ONSITE SEWAGE DISPOSAL SYSTEM

PROPERTY ADDRESS: 11755 Bragdon Wood Drive

RE: 11755 Bragdonwood
BAT Plan

SITE PLAN FOR B.A.T. INSTALLATION
A-544517
 11755 BRAGDON WOOD
 BALAKIRSKY PROPERTY, LOT 1
 SHEET 1 OF 2
 TITLE DEED: 14885/154
 TAX MAP 29, GRID 14, PARCEL 42
 5TH ELECTION DISTRICT, HOWARD COUNTY, MD.
 SCALE: 1" = 40' DATE: 10/10/2014

SHEET 2
TITLE DEED: 14885/154
TAX MAP 29, GRID 14, PARCEL 42
5TH ELECTION DISTRICT, HOWARD COUNTY, MD.
SCALE: 1" = 20' DATE: 10/10/2014

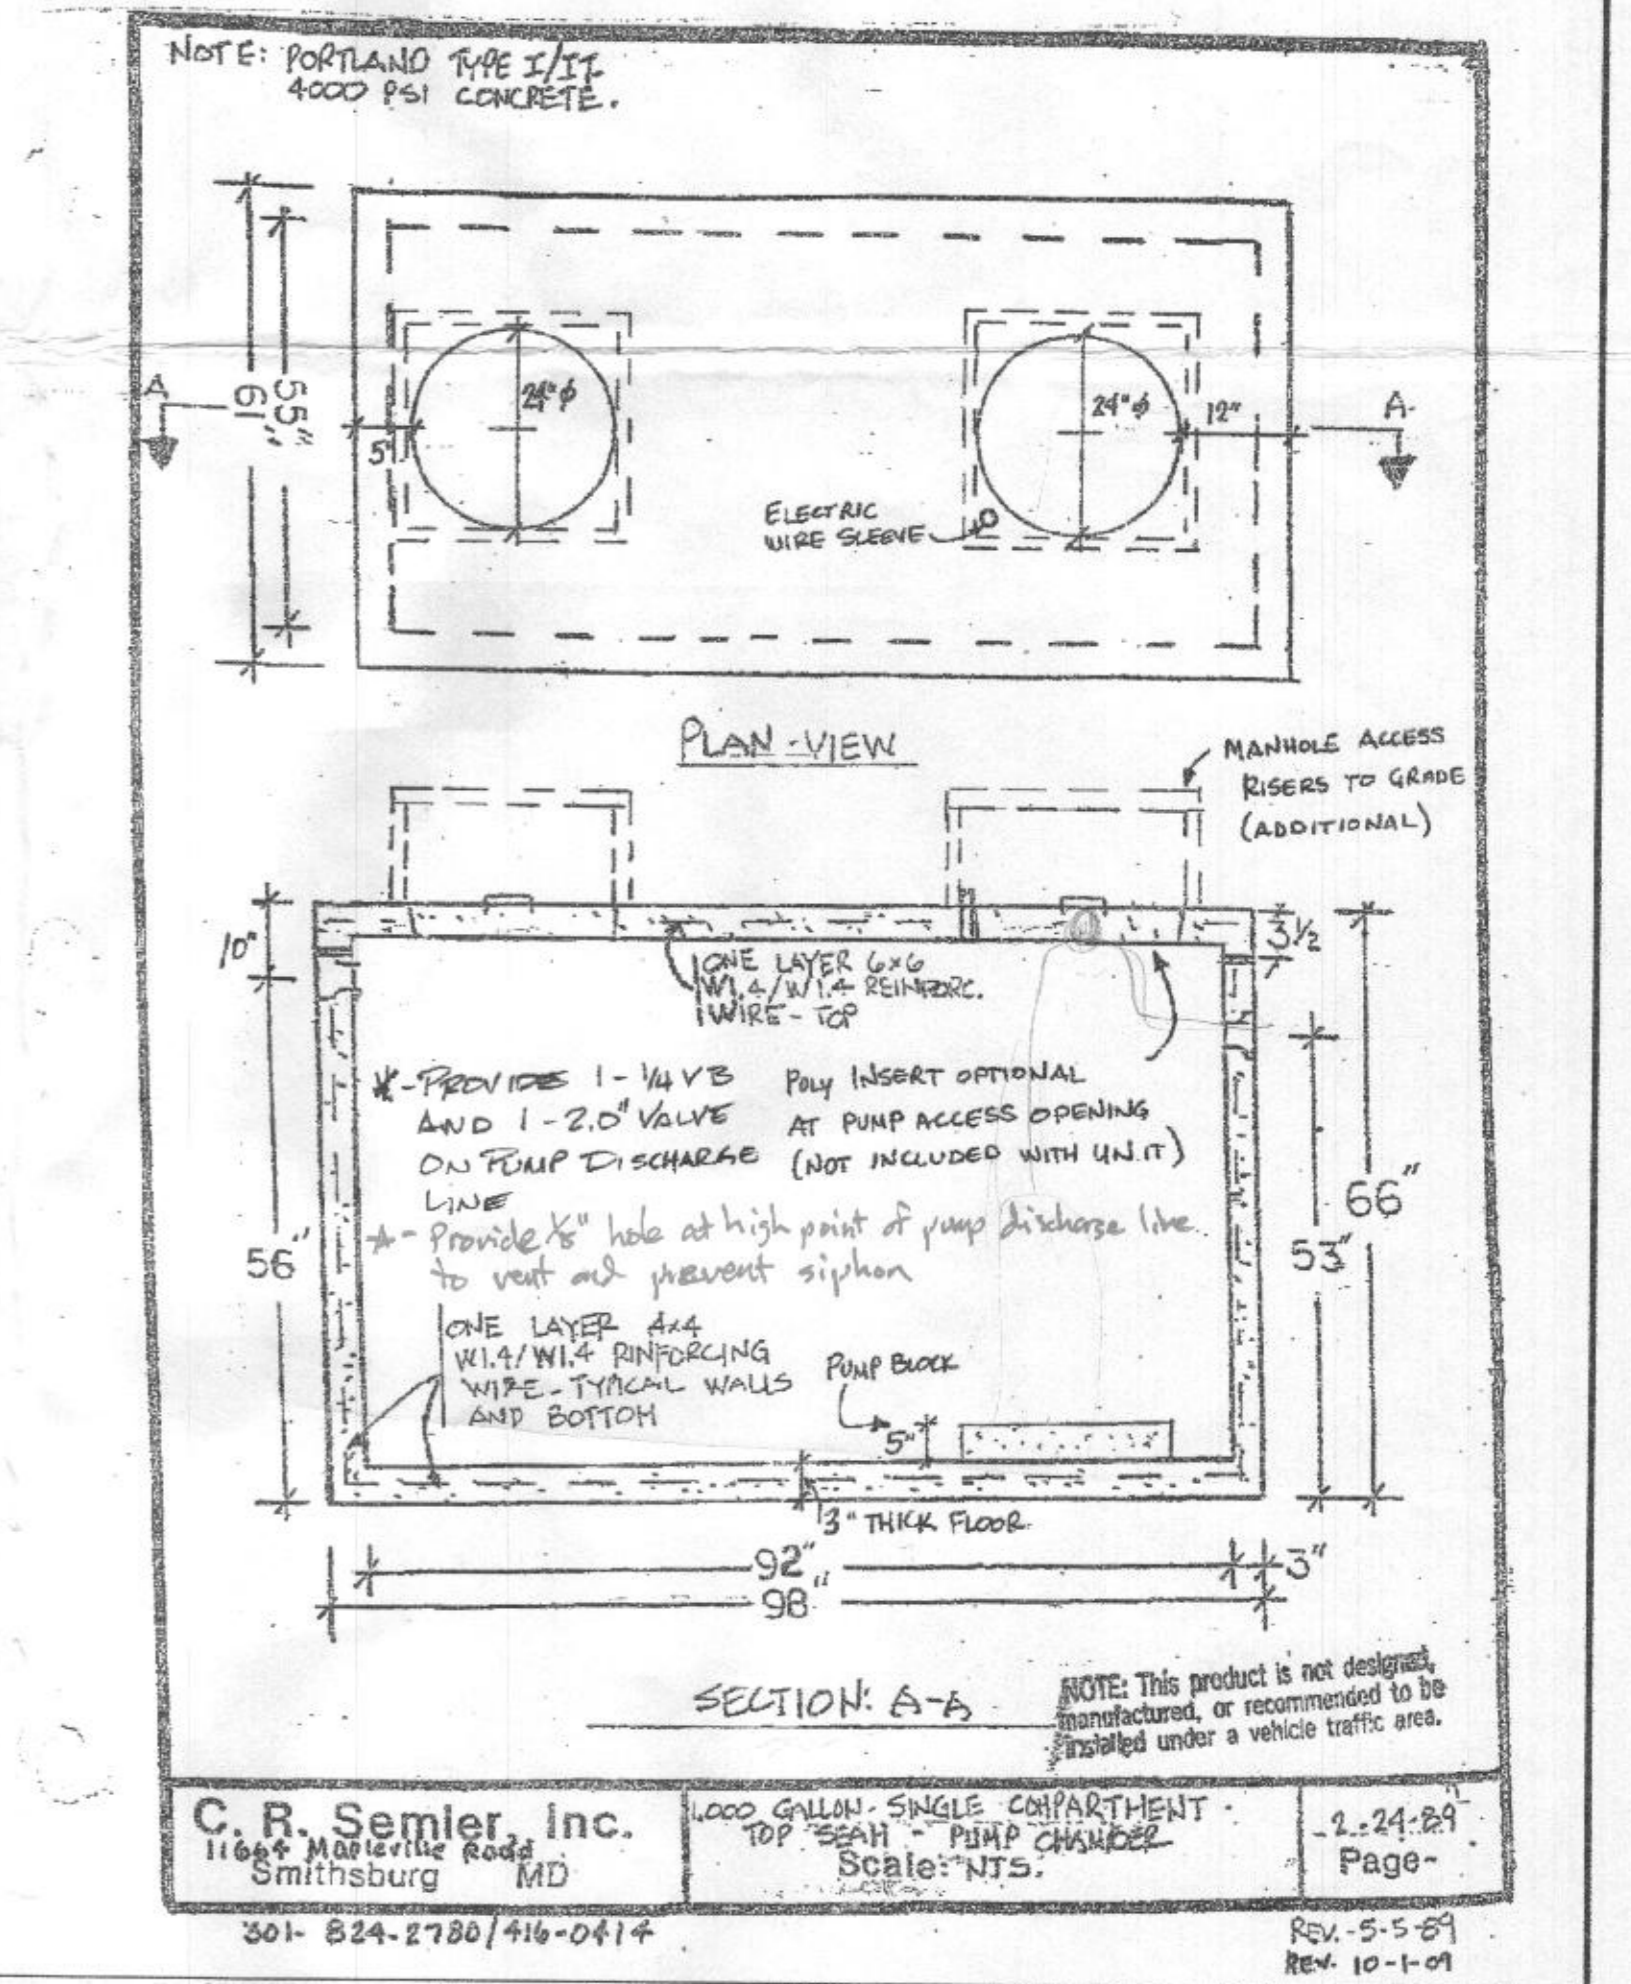
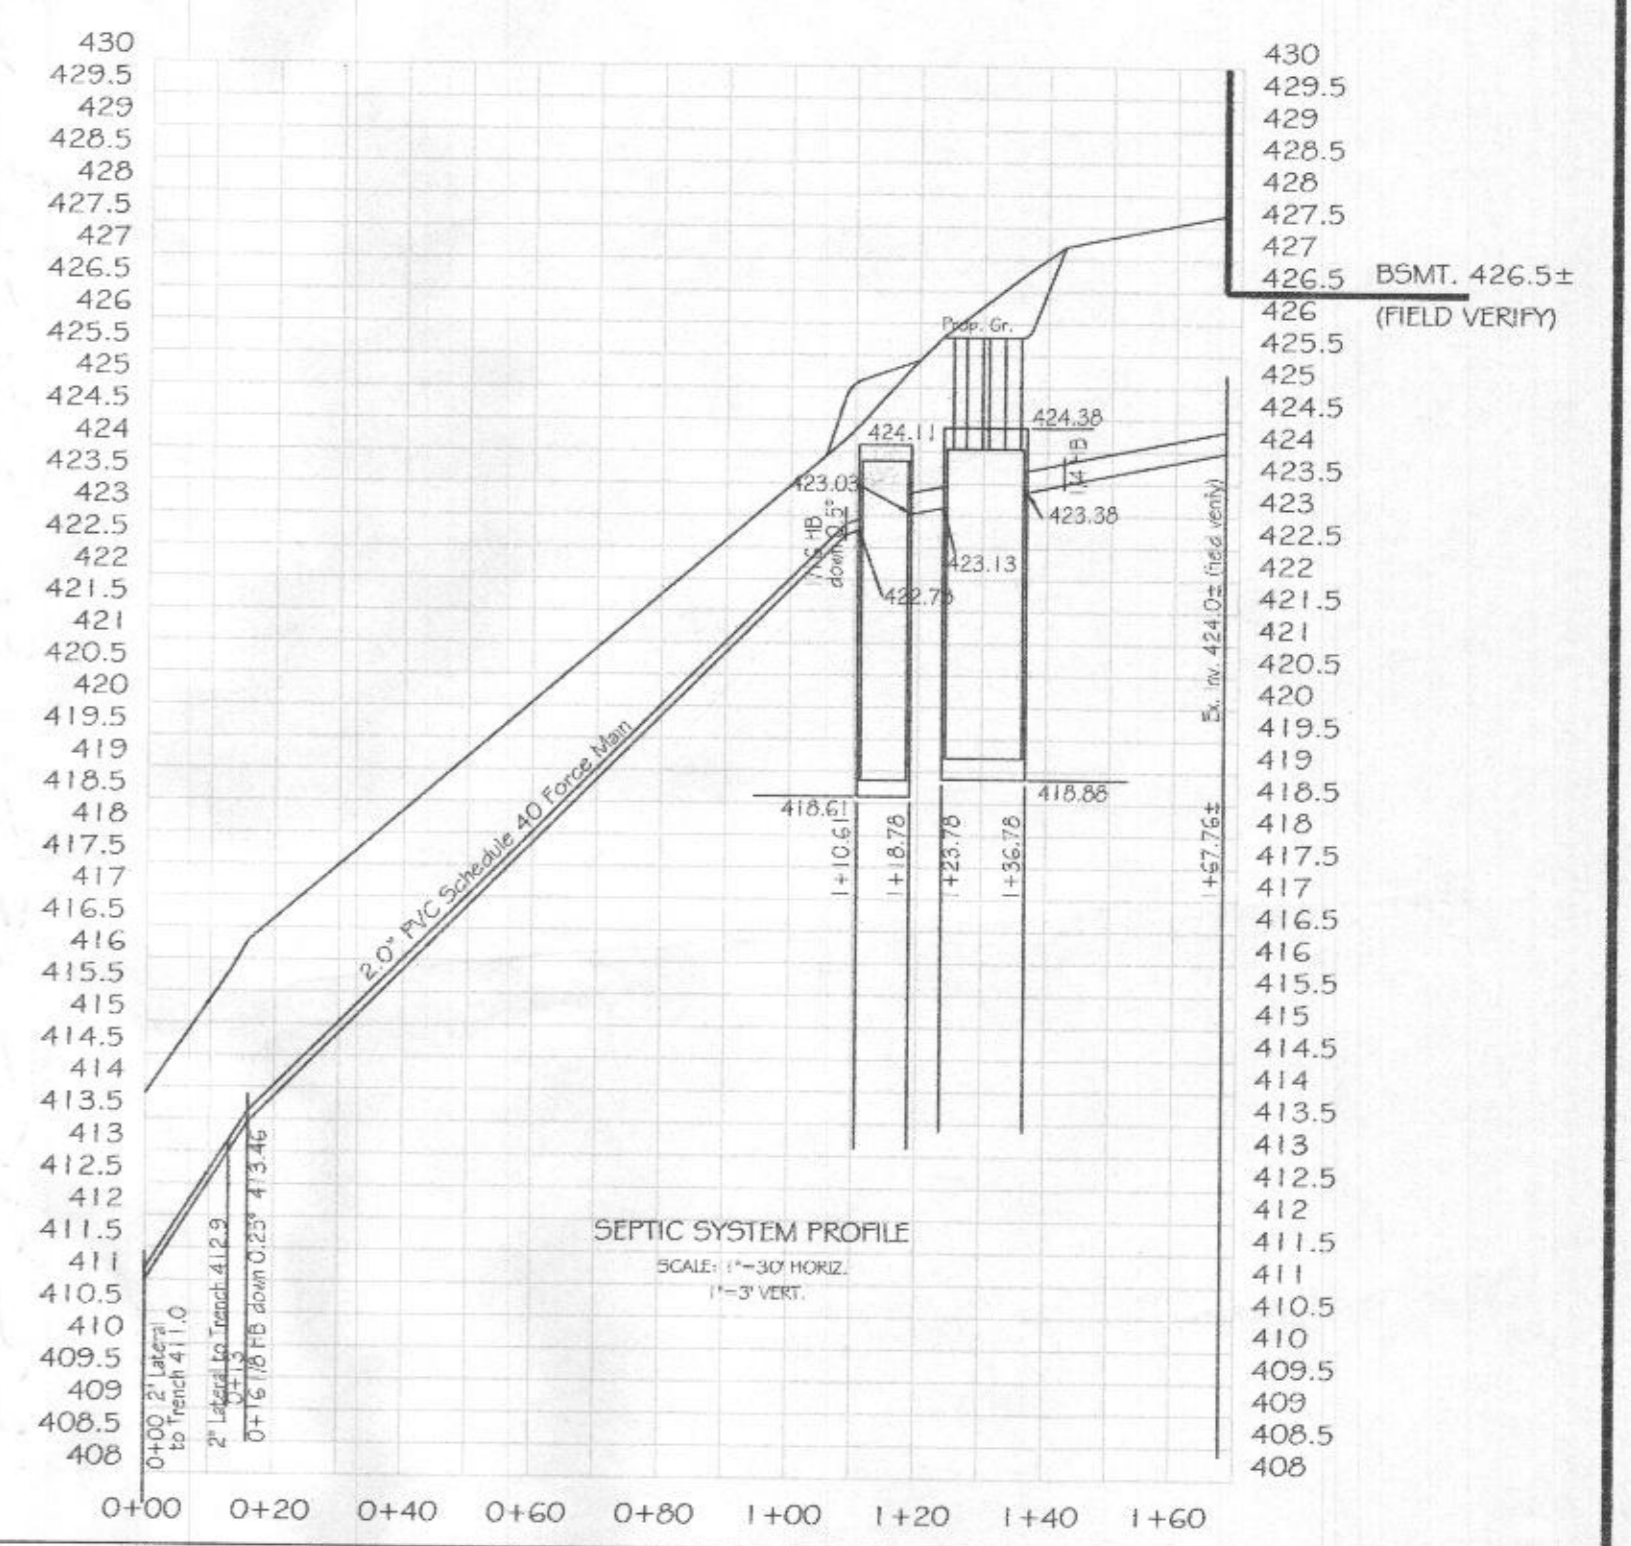
- ✦ BAT notes must be included. *✓ SHEET 1*
- ✦ Include a profile drawing with all invert elevations necessary for installation. *✓ SHEET 2*
- ✦ If you are proposing to use the Eco-pod BAT unit, all components must be shown on plan. Blower is not shown. *✓ SHOWN ON BOTH SHEETS*
